# Request to modify a major project

06\_0184

Reference No. 06623099-698-L-Rev1

**PASMINCO COCKLE CREEK SMELTER:  
PROPOSED DESIGN CHANGES FOR CONTAINMENT CELL CAP**

Figure 1: Concept of proposed geocomposite capping system

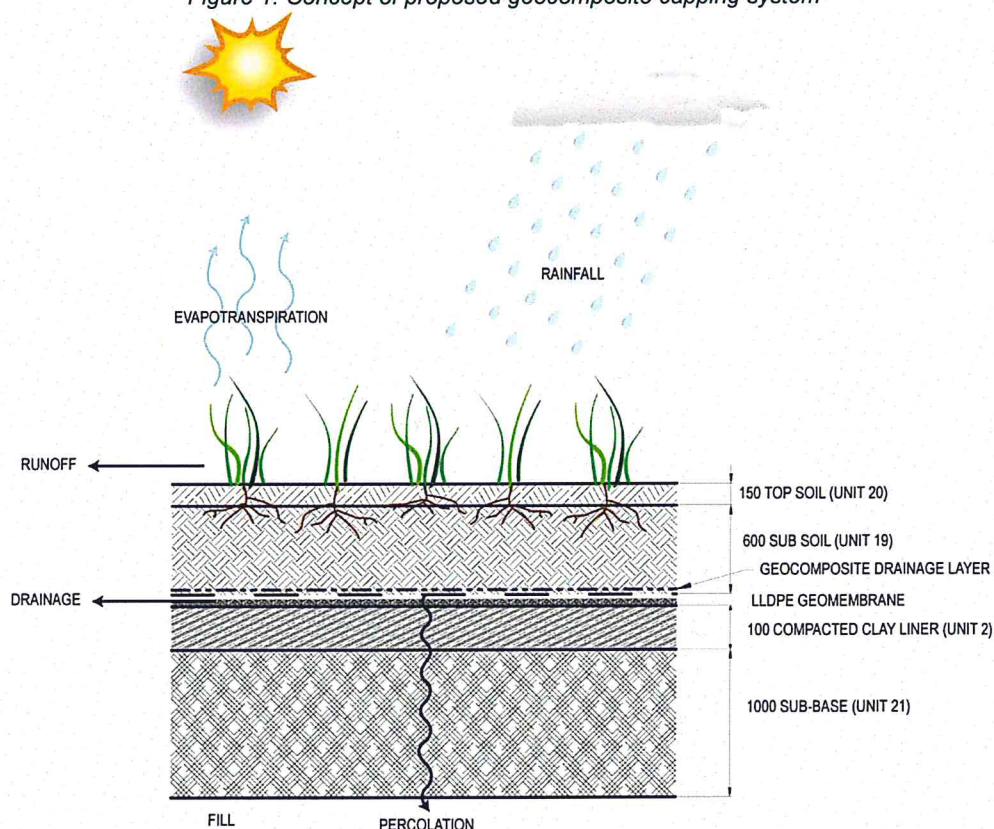
The current capping system design for Cell 1 and proposed design revisions are identified in Table 2 below and discussed subsequently. Revisions are proposed for the drainage layer and barrier layer components. The proposed design revisions apply primarily to the portions of the capping system on the top deck of Cell 1 that have not yet been constructed.

Component (listed from top to bottom)	Existing Design	Proposed Design
Topsoil Layer	150 mm thick; Topsoil specification (Unit 20)	No change proposed
Subsoil Layer	600 mm thick; Subsoil specification (Unit 19)	No change proposed
Drainage Layer	150mm thick; Subsoil gravel drainage layer specification (Unit 18); Overlain by filter geotextile (Unit 13)	Geocomposite drain (geonet drain core with geotextile filter bonded to both sides); thickness 5-10 mm.
	Subsoil drainage collection pipes (Unit 17) within subsoils drainage layer	No change proposed to pipe material; revised pipe layout and spacing
Barrier Layer	no geomembrane	LLDPE geomembrane (overlying clay liner); thickness 1 mm
	600 mm thick; Clay liner material (Unit 2)	100 mm thick; Clay liner material (Unit 2)

Component (listed from top to bottom)	Existing Design	Proposed Design
Sub Base	1000 mm thick: Sub base material (*select Unit 21)	No change proposed
Total System Thickness	2500 mm	1860 mm

The following figure shows the revised design proposed for the capping system for the top deck of Cell 1.

The proposed design revision replaces a relatively thick layer of Unit 2 Clay with a thin layer of Unit 2 Clay overlain by a geomembrane. In the proposed design the thin layer of Unit 2 clay provides a bedding layer for the geomembrane that serves two functions as follows: (i) clay layer will protect the geomembrane because it will not contain any gravel or rock particles that could puncture or penetrate the geomembrane; and (ii) clay layer in contact with the geomembrane provides a composite liner effect whereby the rate of water leakage through any defects in the geomembrane is likely to be significantly less than if the geomembrane was placed on more permeable soil. Because the development of a full composite liner effect (i.e., an order of magnitude or more reduction in leakage rate) is typically documented for clay layers that are substantially thicker than 100 mm, we consider that only a partial composite effect will likely be achieved with the proposed design. However, even a partial composite effect would result in leakage rates several times lower than for a single clay liner or single geomembrane. On this basis alone, it can be demonstrated that environmental impacts caused by infiltration through the proposed cap are likely reduced from the cap design which is currently approved, assuming that the cap is maintained suitably as per the maintenance requirements.

The proposed design revisions to the barrier layer and the drainage layer on the top deck of Cell 1 are considered technically acceptable and will require appropriate detailed design and CQA implementation. In addition, the current Cell Operation and Maintenance Plan (COMP) will require revisions to address the presence of a geomembrane and overall thinner capping system.
